City of Portland, Maine – Building or Use Permit Application 389 Congress Street, 04101, Tel: (207) 874-8703, FAX: 874-8716

Location of Construction: 39 Hawthorne St		Owner: John Kuntz		Phone: 775-0949		Permit No: 970439
Owner Address: 39 Hawthorne St- Ptld ME 04103		Lessee/Buyer's Name:		BusinessName:		
Contractor Name: Mike Mathieu		Address: u/k Harrison		Phone: u/k		<div style="border: 2px solid black; padding: 5px; text-align: center;"> PERMIT ISSUED MAY 13 1997 CITY OF PORTLAND </div>
Past Use: 1-fam w 1 set/stairs		Proposed Use: 1-fam w deck & 2 sets/stairs		COST OF WORK: \$ 400 FIRE DEPT. <input type="checkbox"/> Approved <input type="checkbox"/> Denied Signature:		
Proposed Project Description: <i>There was a porch there original replacing with deck - \$ const deck & 2 sts/stairs</i>		PEDESTRIAN ACTIVITIES DISTRICT (P.A.D.)		Action: Approved <input type="checkbox"/> Approved with Conditions: <input type="checkbox"/> Denied <input type="checkbox"/> Signature: Date:		Zone: CBL Zoning Approval: Special Zone or Reviews: <input type="checkbox"/> Shoreland <input type="checkbox"/> Wetland <input type="checkbox"/> Flood Zone <input type="checkbox"/> Subdivision <input type="check

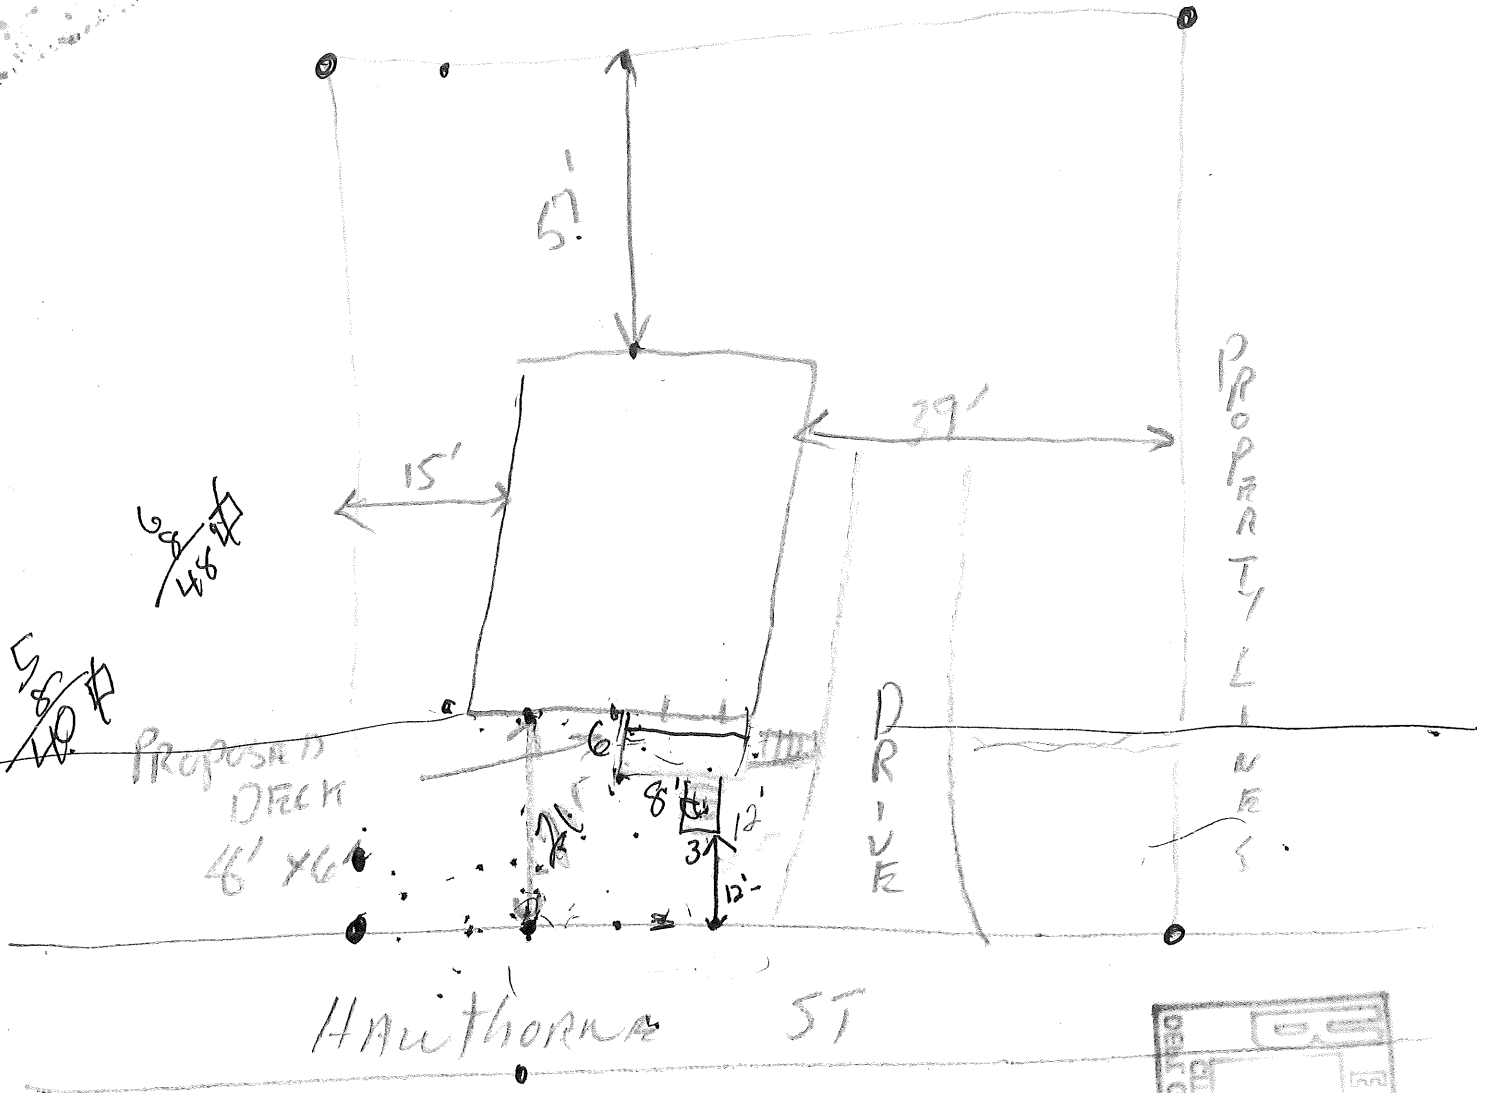
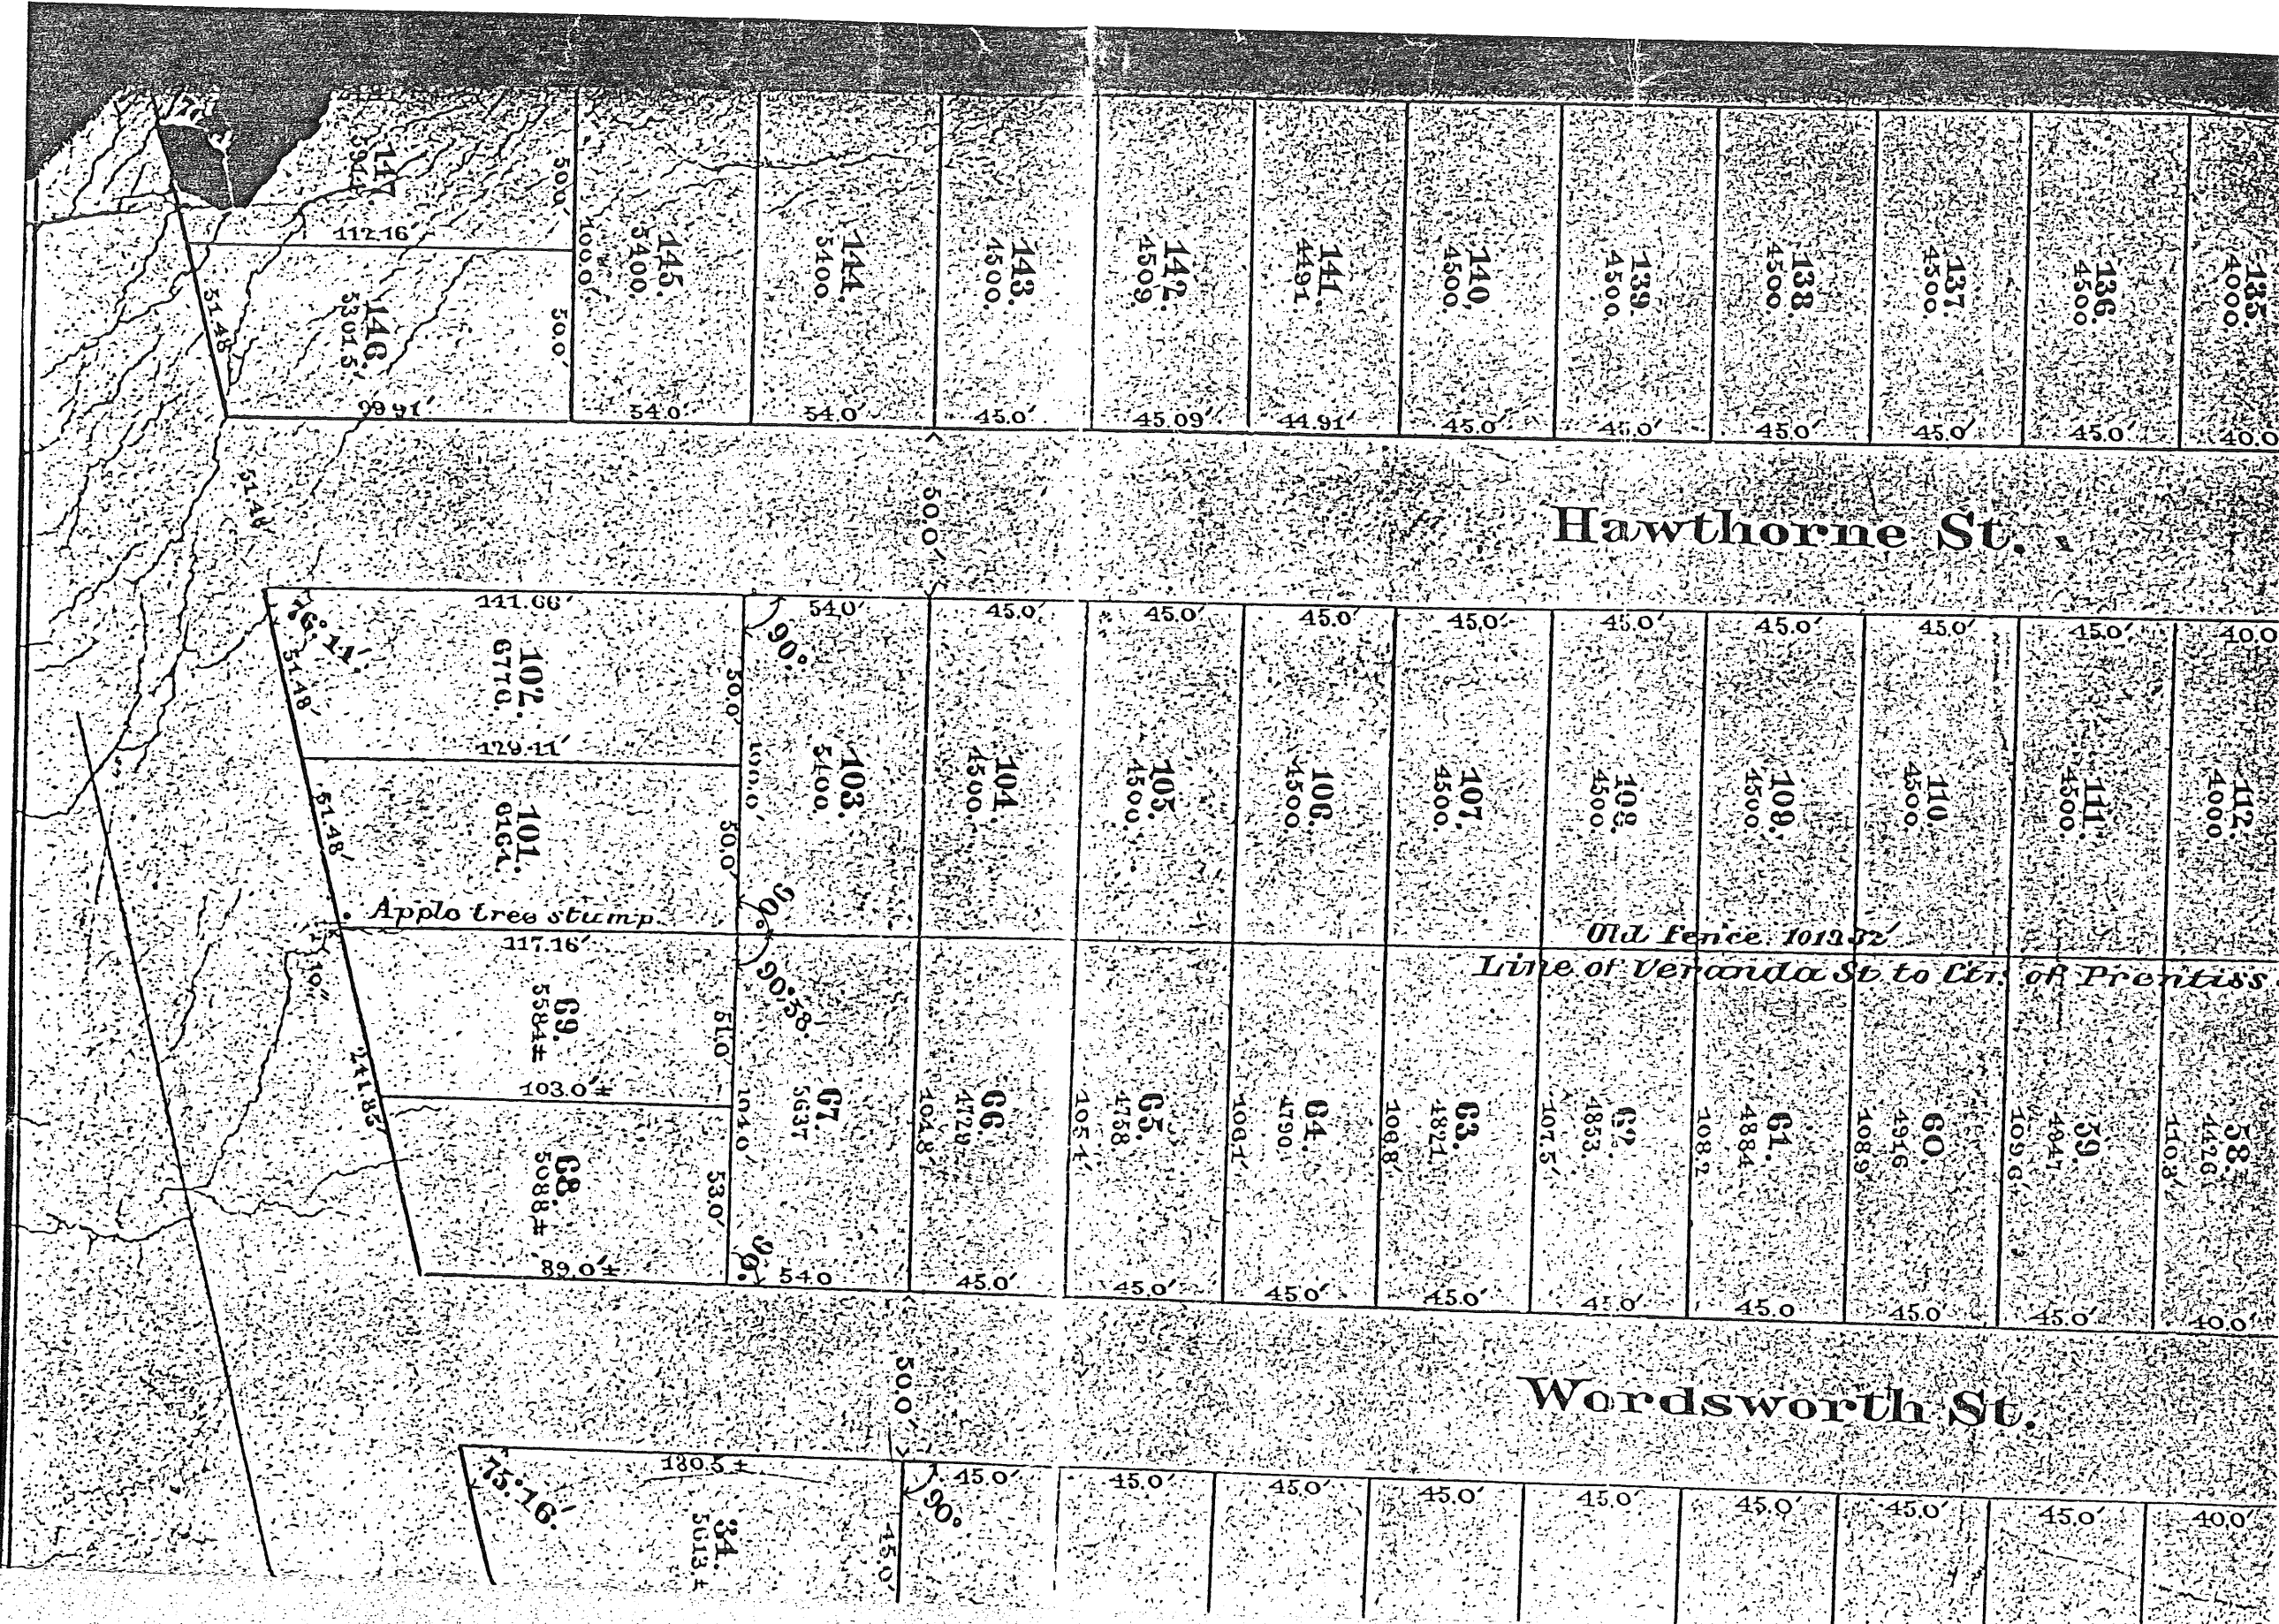
- 25. All electrical and plumbing permits must be obtained by a Master Licensed holders of their trade.
- 26. The proposed Front Stairs ~~to be~~ NOT allowed - The rest of the proposed deck must be in the same footprint as the original porch
